Docket No. 50-336  
B18294

**Millstone Nuclear Power Station, Unit No. 2**  
**Response to a Request For Additional Information Regarding Proposed Revision to**  
**Final Safety Analysis Report**  
**Fuel Centerline Melt Linear Heat Rate Limit (PLAR 2-00-2)**

**Response to a Request For Additional Information Regarding Proposed Revision  
to Final Safety Analysis Report  
Fuel Centerline Melt Linear Heat Rate Limit (PLAR 2-00-2)**

**FIGURE 14.1.5.2-2**  
**STEAM GENERATOR BREAK FLOW (HFP POST-SCRAM STEAM LINE OUTSIDE CONTAINMENT BREAK WITH OFFSITE POWER AVAILABLE)**

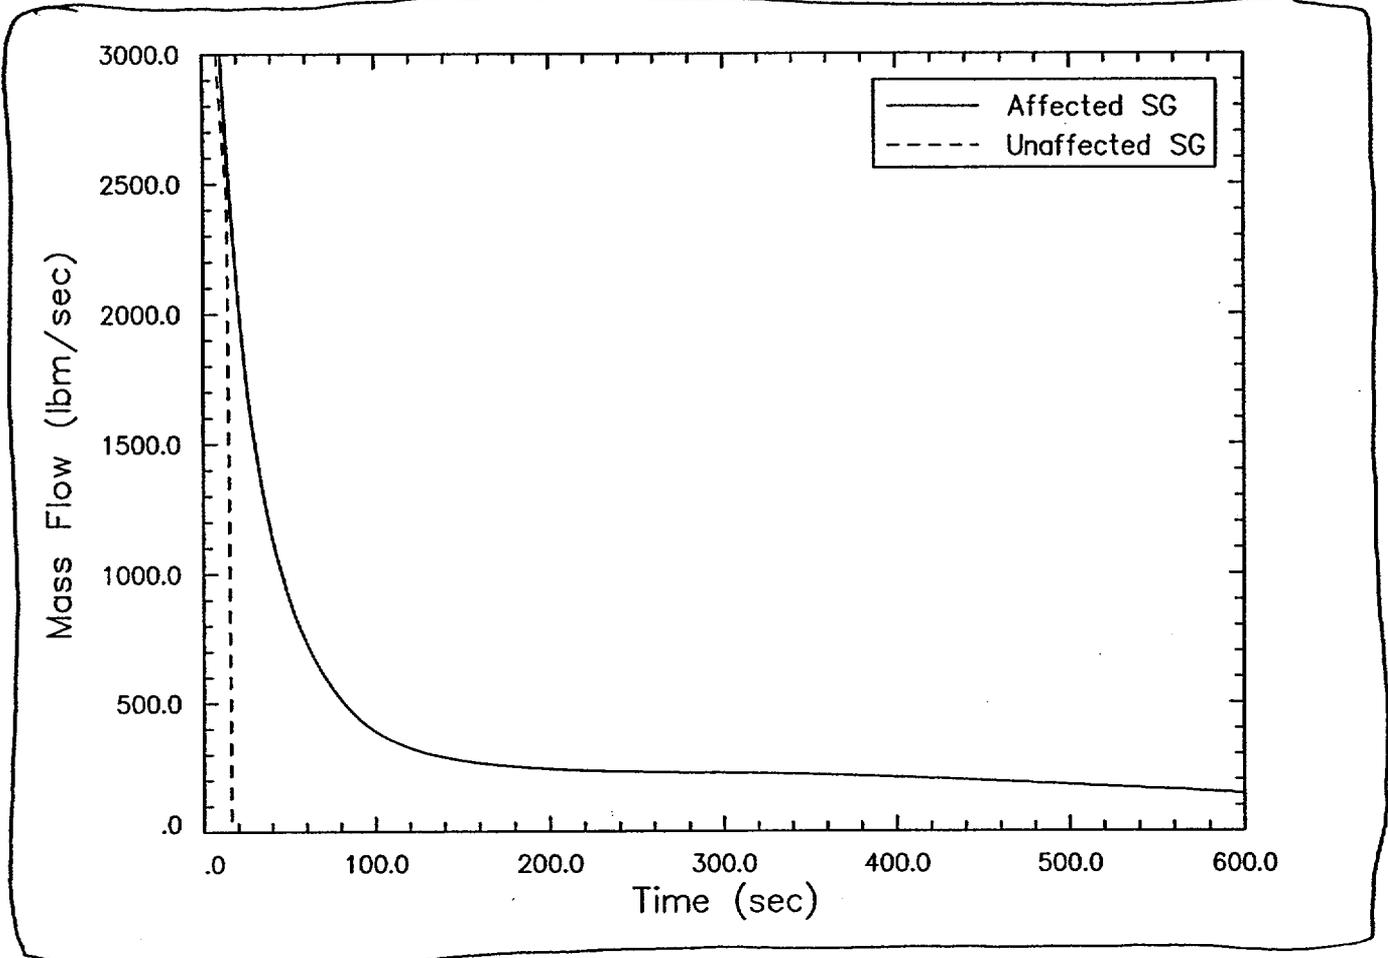
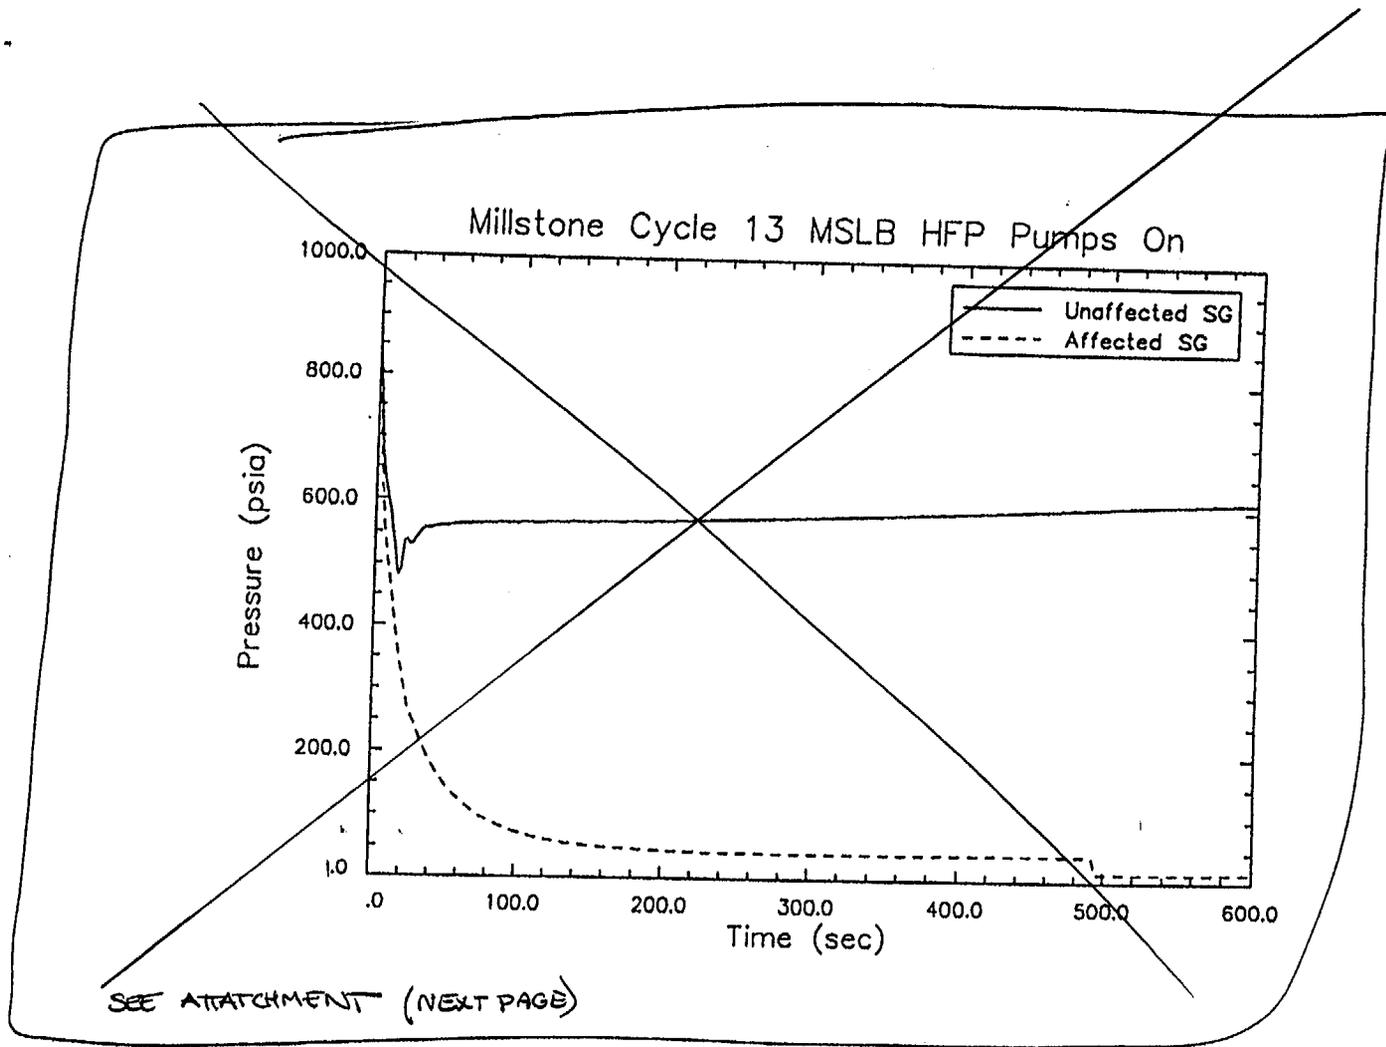
~~Figure 14.1.5.2-2 HZP Offsite Power Available (Break Flows)~~

Replace with figure 3

FIGURE 14.1.5.2-3  
STEAM GENERATORS' SECONDARY PRESSURES (HFP POST-SCRAM STEAM LINE OUTSIDE CONTAINMENT  
BREAK WITH OFFSITE POWER AVAILABLE)

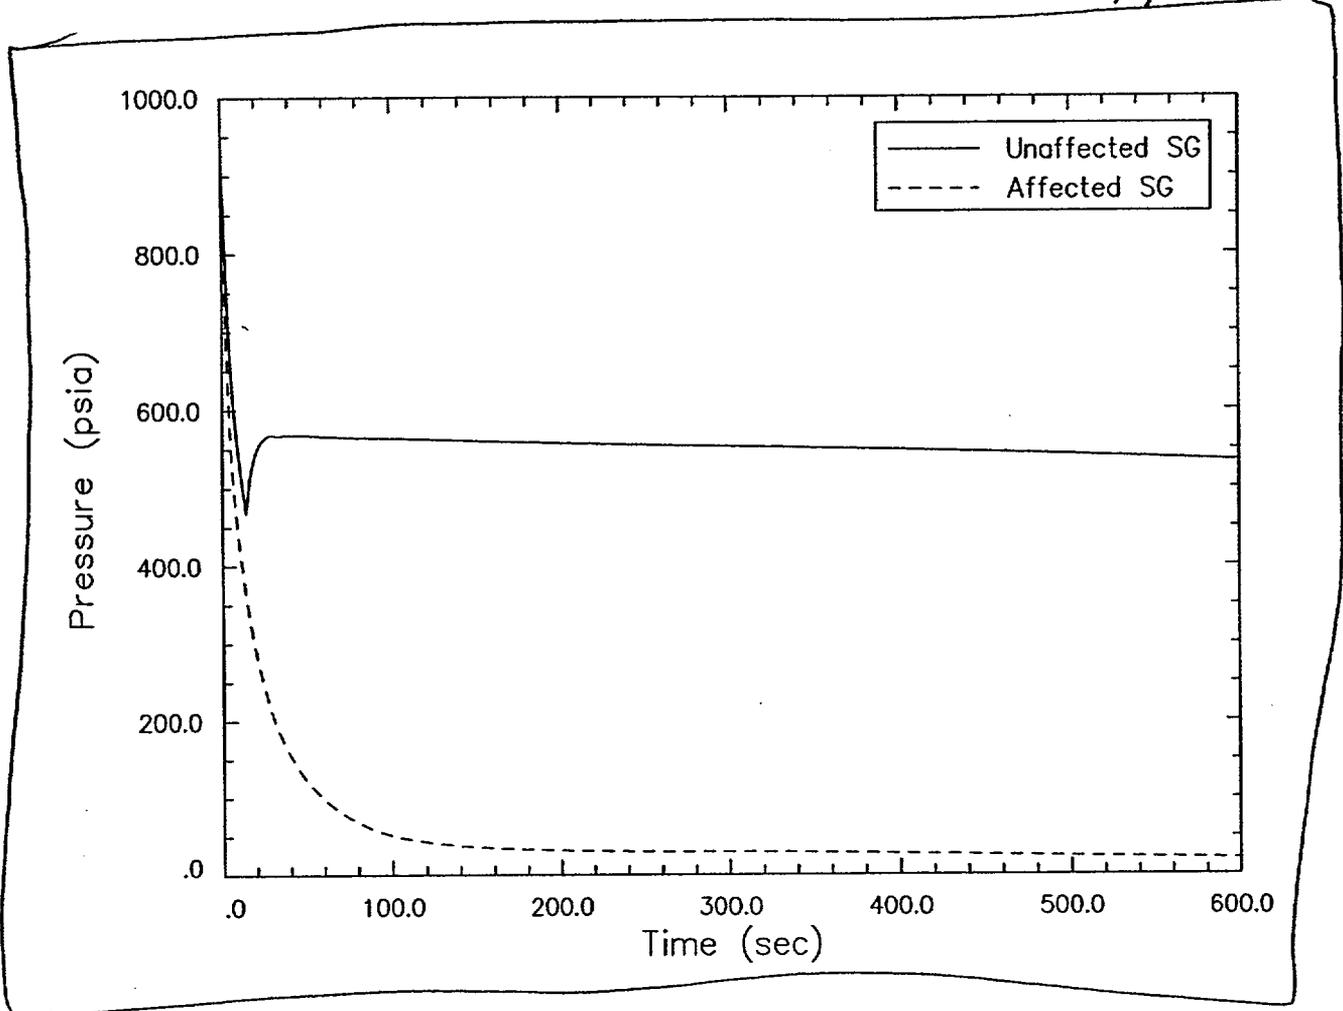
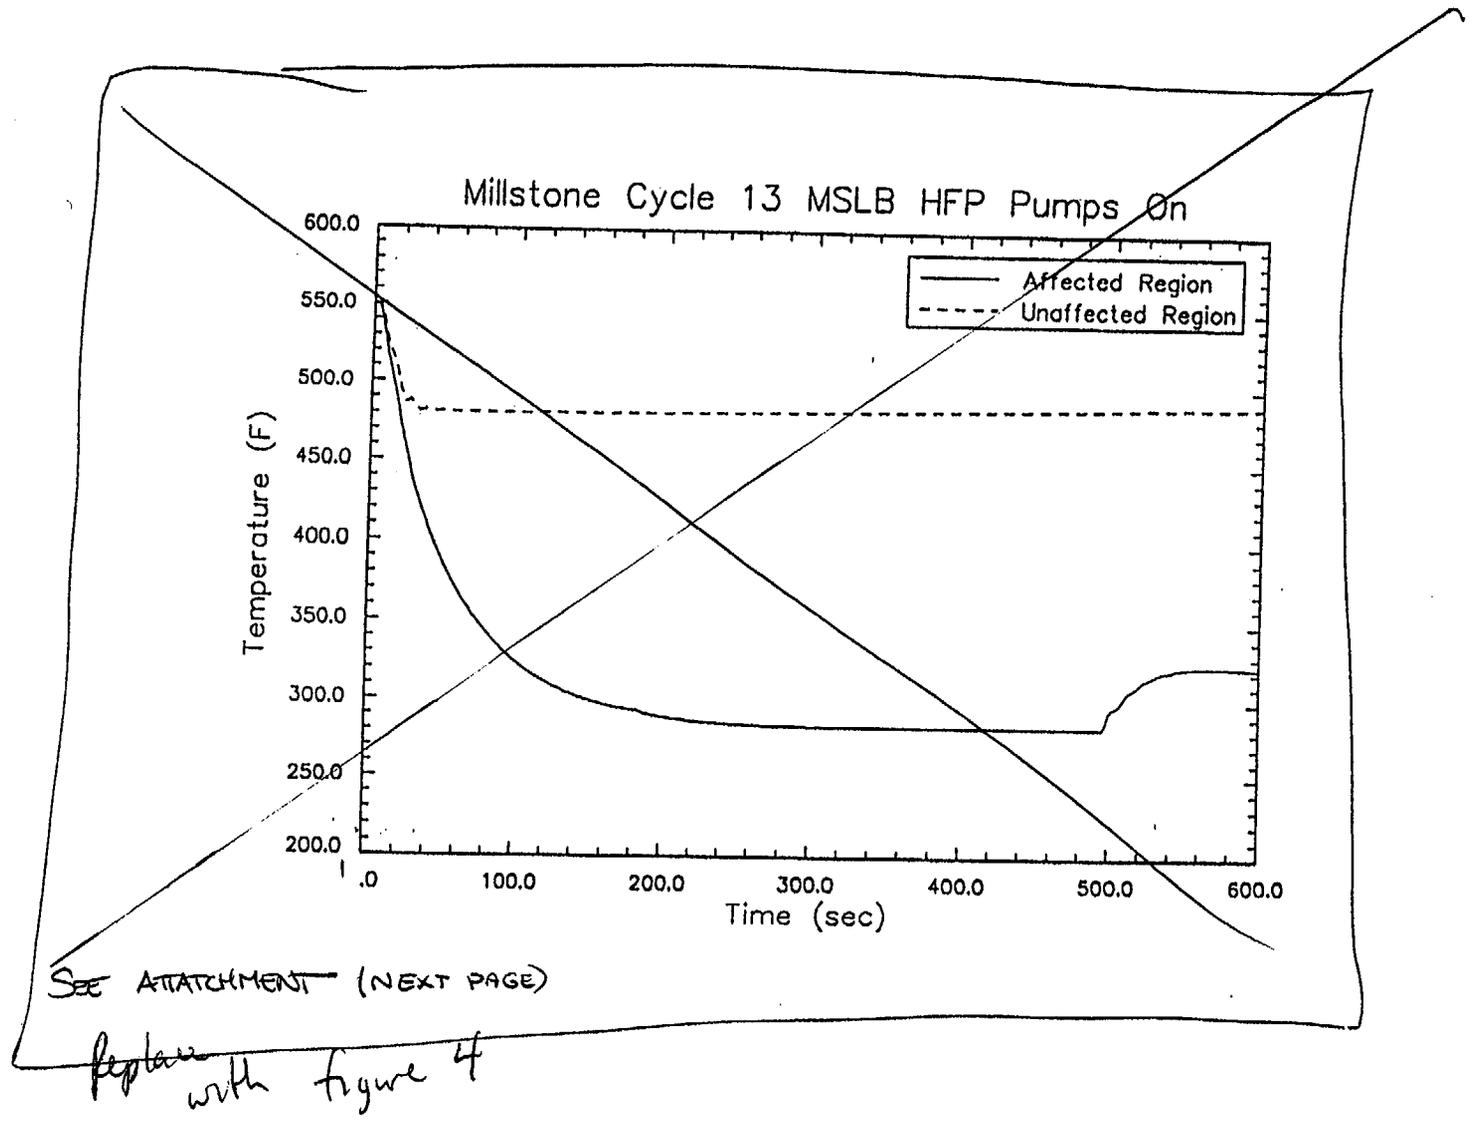
~~Figure 14.1.5.2-3 HZP Offsite Power Available (Steam Generators' Secondary Pressures)~~

SEE ATTACHMENT (NEXT PAGE) *Replace with figure 5*

<sup>H2P</sup> **FIGURE 14.1.5.2-9**  
**REACTOR POWER (HFP POST-SCRAM STEAM LINE OUTSIDE CONTAINMENT BREAK WITH OFFSITE POWER AVAILABLE)**

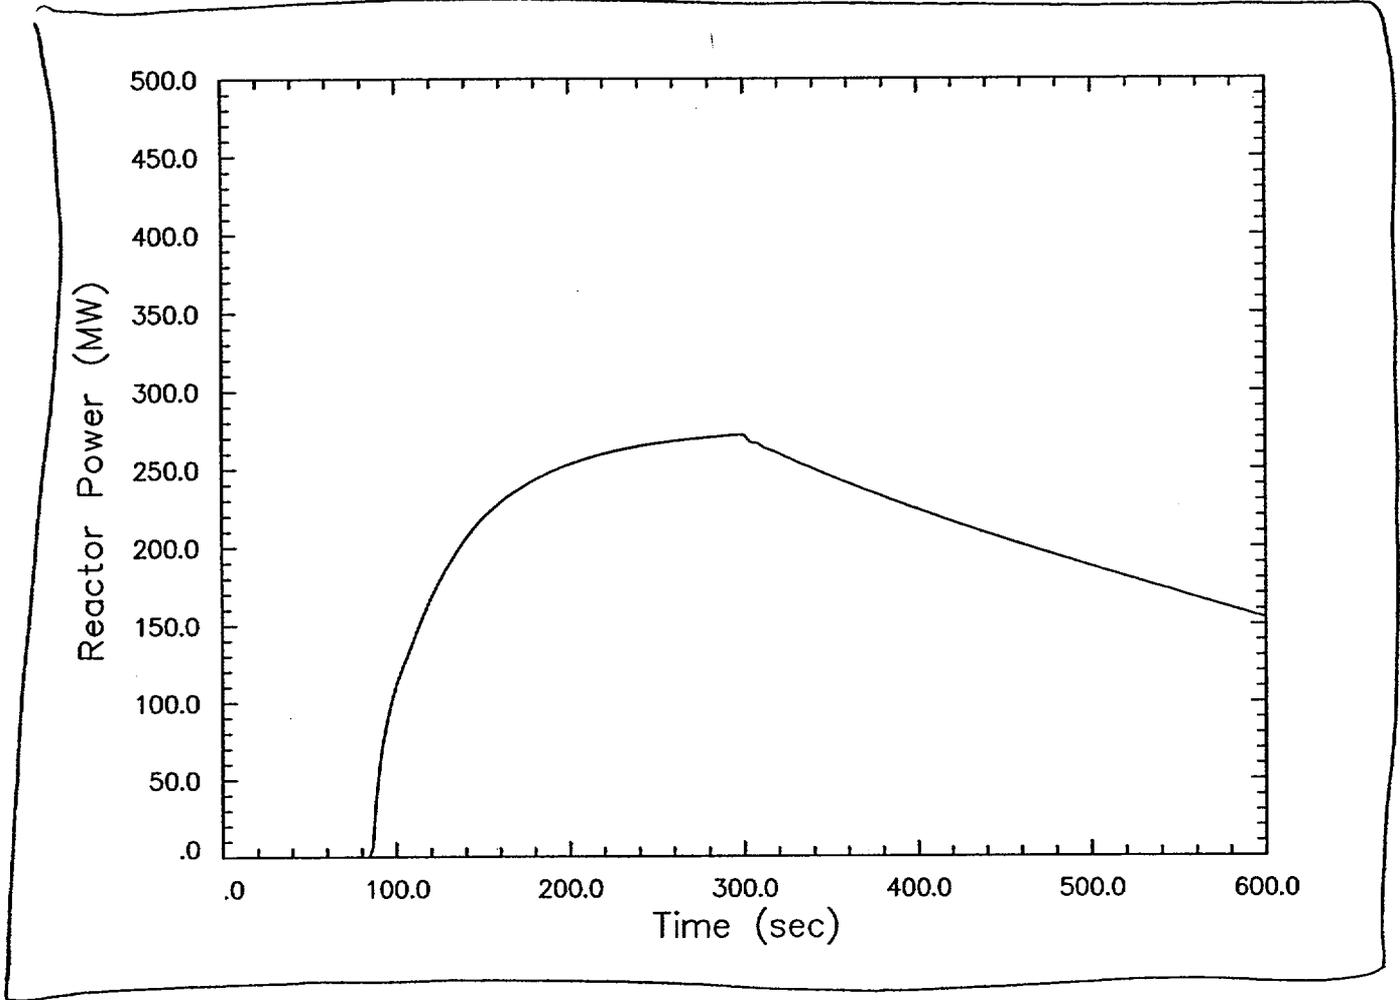
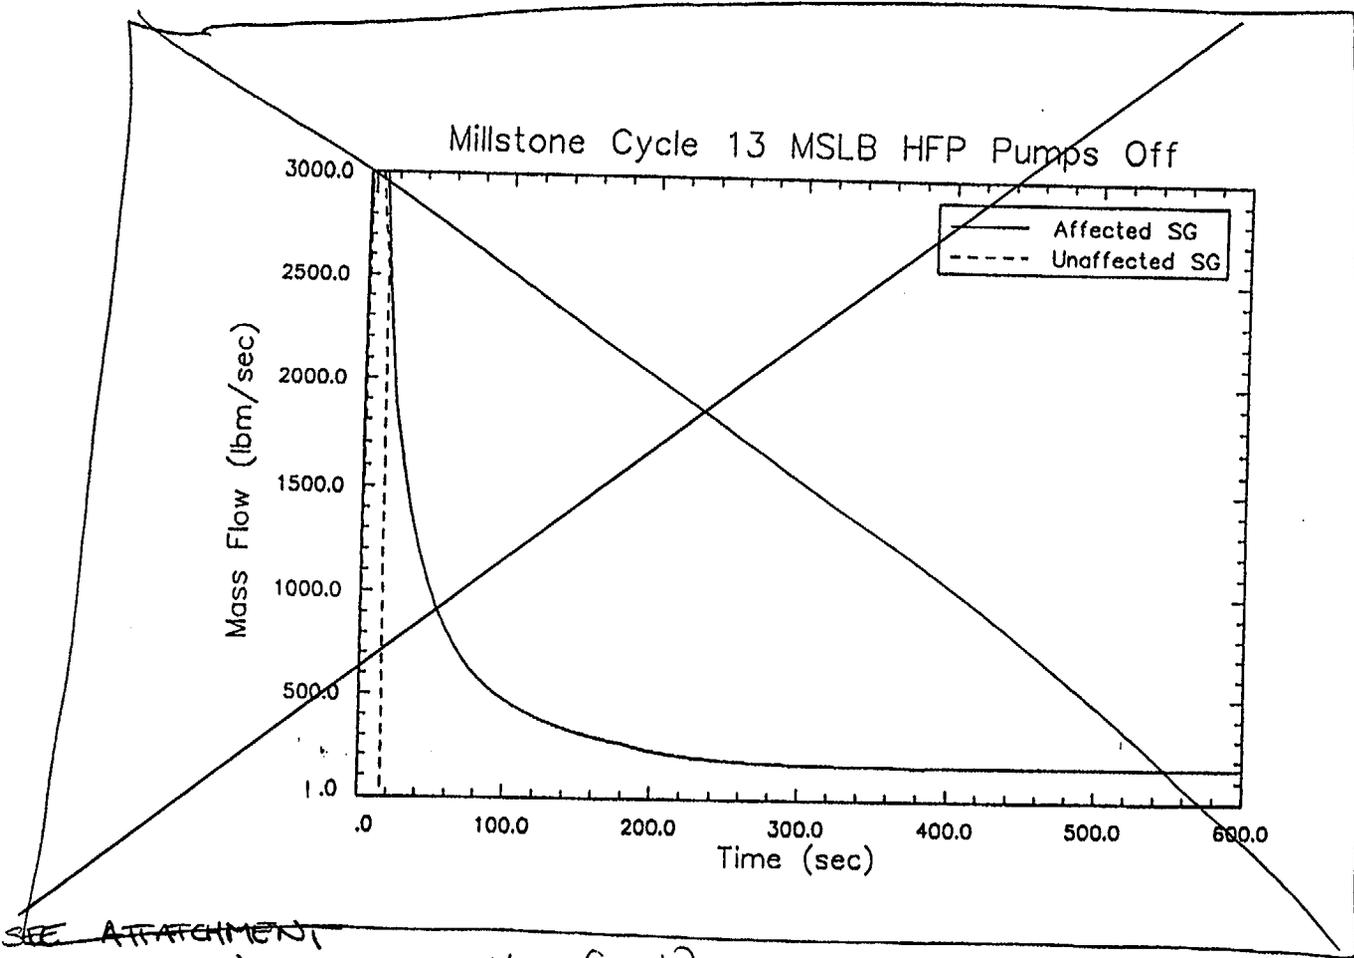
~~Figure 14.1.5.2-9 HZP Offsite Power Available (Reactor Power)~~

~~SEE ATTACHMENT~~  
(NEXT PAGE) *Replace with fig 10*
